FAUNTLEROY WAY APARTMENTS | DESIGN RECOMMENDATION

April 6, 2017

RESPONSES TO EARLY DESIGN GUIDANCE

SUMMARY OF EDG BOARD RECOMMENDATIONS

EXTRUDED BAR WINDOW DETAIL AT FIBER CEMENT

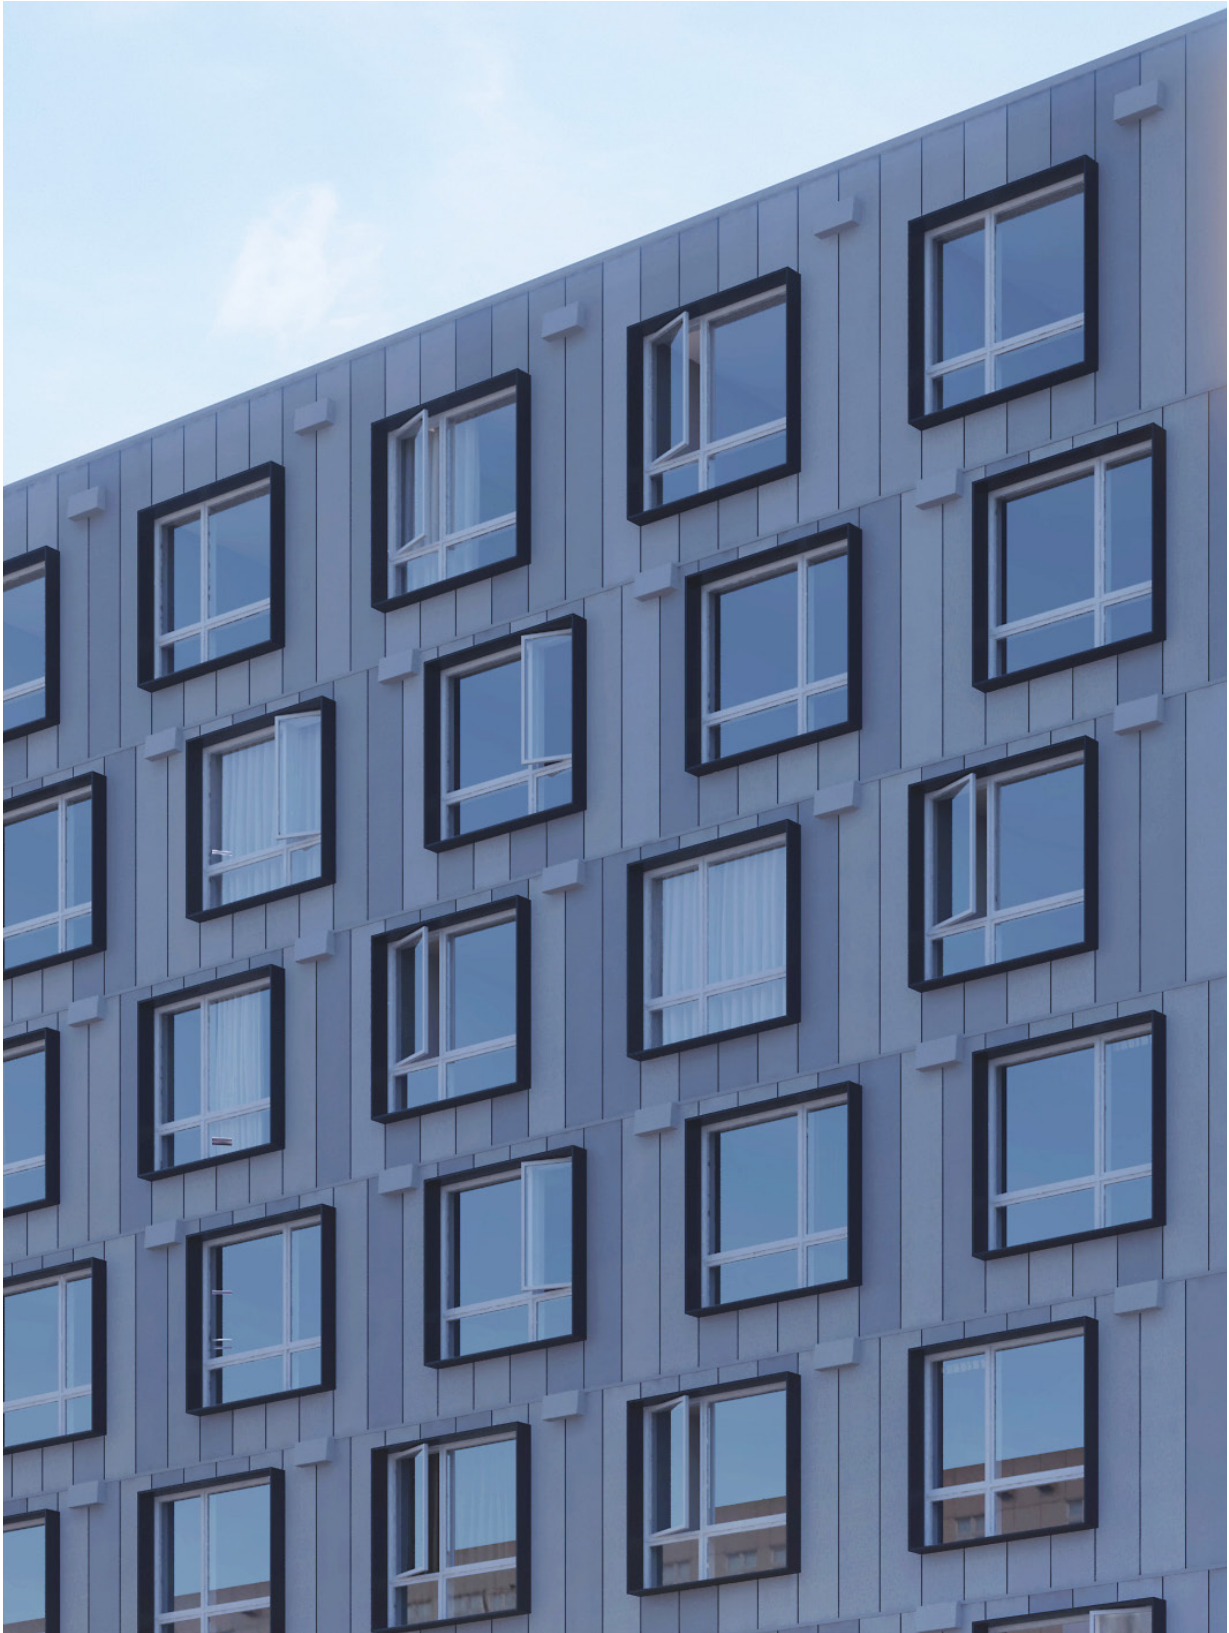
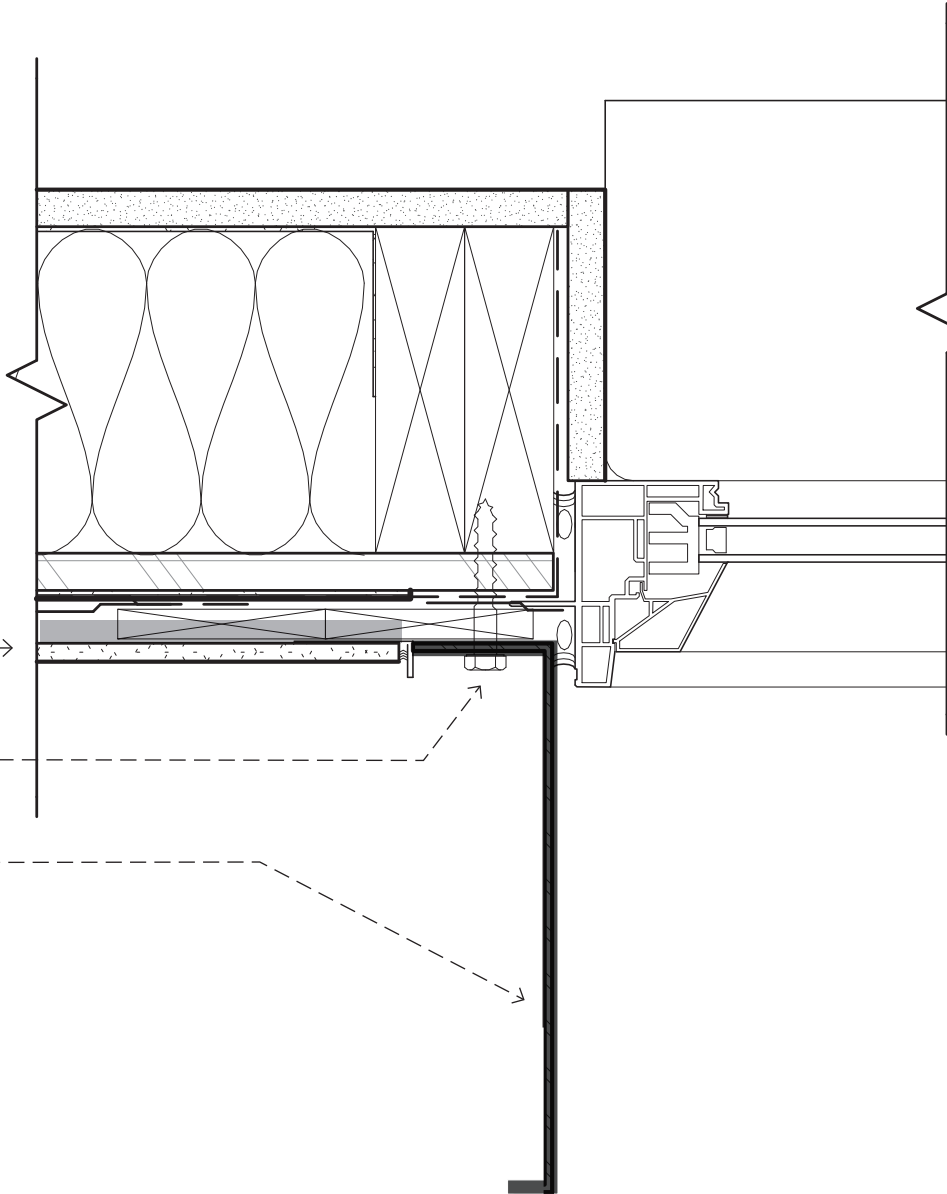
1b. There was support for the “foundry” design concept of two shifting bars on a solid base, noting it was strong and simple. The Board agreed that the rendering on page 35 was less compelling because the concept appeared lost in the materials. The applicant should explore minor adjustments to the massing and additional ways to further strengthen the design concept expression. This could be achieved through materiality, shifting parapet heights, or other ways.

Detailing around the living area windows of each unit emphasizes the extruded sliding bars around the building

- Fiber Cement ----->
- Exposed Fasteners attached to doubled furring strip (connection to fiber cement is adjacent) ----->
- Painted Metal Brake Metal Shape ----->

WINDOW GRID ORGANIZATION

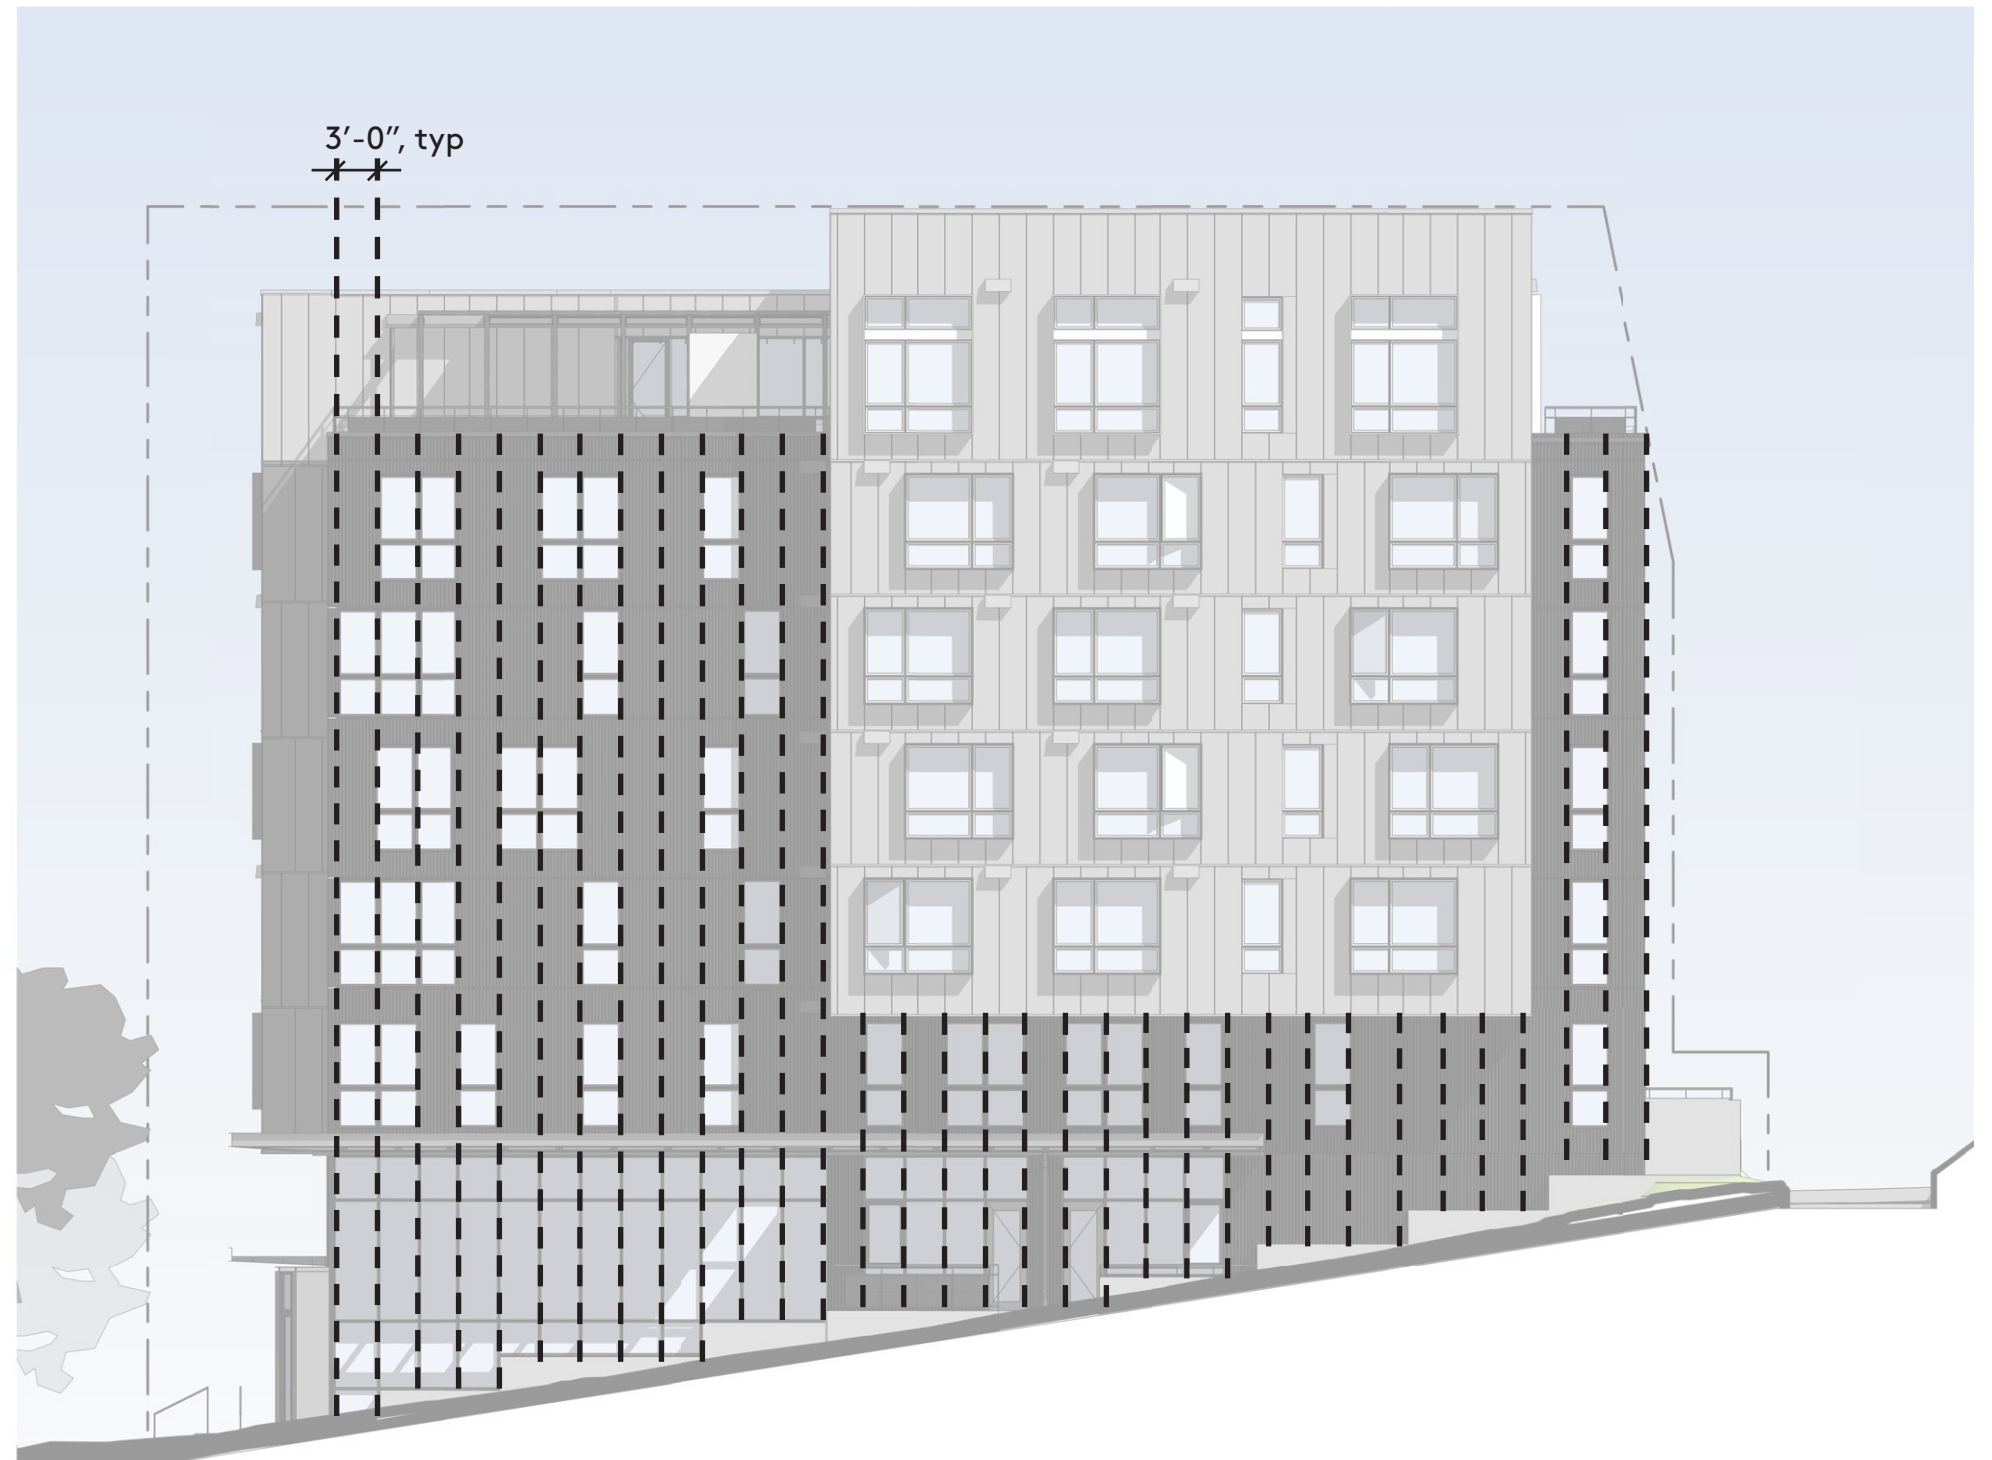
LU-7. - At EDG, the corner mass contained windows and siding materials of roughly the same size and windows that wrapped the corner. These austere modern touches were emphasized and encouraged in the Board's guidance. *Revise the corner mass to include larger panel sizes, larger windows, and wrapped corner windows.*

- Corrugated metal panel cladding is utilized throughout the project as a holistic design element that unifies residential and non-residential uses around all sides of the building.
- The alignment of windows uses a rigorous underlying grid with offset windows that are taller than the windows on the 'bars'.
- Playful grid-alignment of windows at the metal panel is integrated along all facades of the building including the storefront along the ground level.
- The proposed design includes the same number of corner windows as was shown in the EDG packet, but with a more refined pattern which works with the layout of the apartment units.

ENLARGED ELEVATION AT FIBER CEMENT BOARD

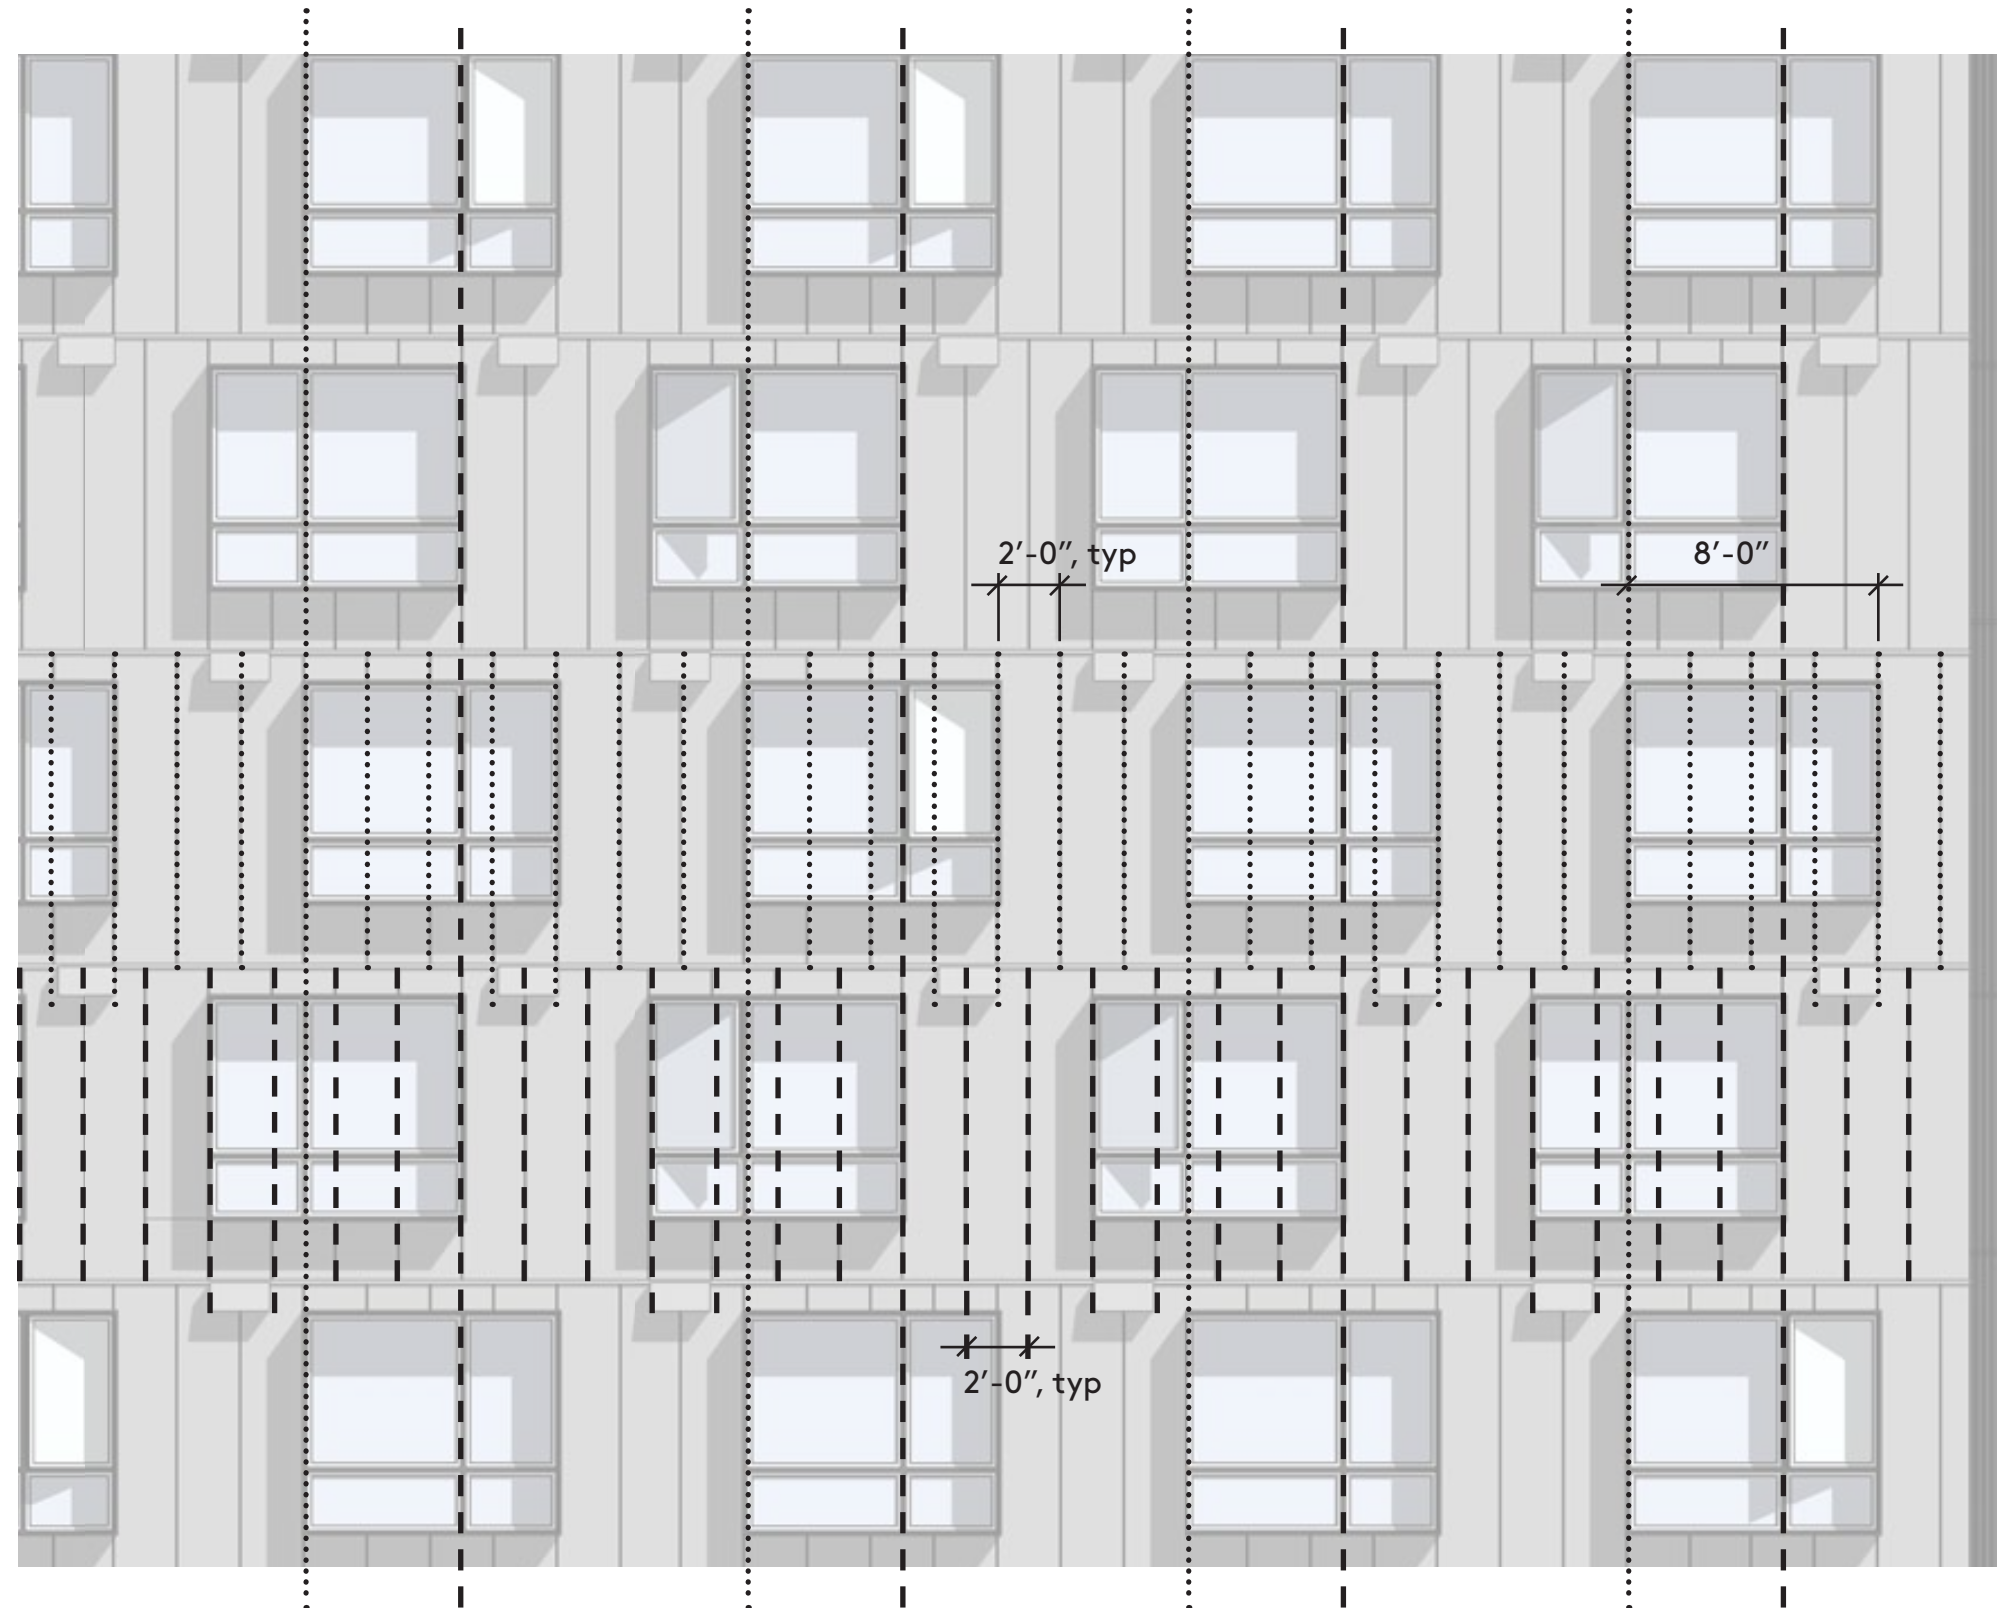
LU-5. - The two bar elements are muddled by the small size of the hardie panels and the vents.
Detail the hardie so it works more closely with the windows and further resembles the character sketch on page 35 of the EDG packet. Consider using vent stacks instead of wall vents to simplify the facades.

- The reveals of fiber cement panels are ½" and will be painted to match the panels, which minimizes the visible impact of the joint pattern on the bars- ultimately strengthening the two bar elements as uniform masses.
- The scale of the fiber cement reveals breaks up the bar mass and provides simple detailing along all facades.
- The panels are carefully coordinated with the window sizes and locations to create a unified building skin.
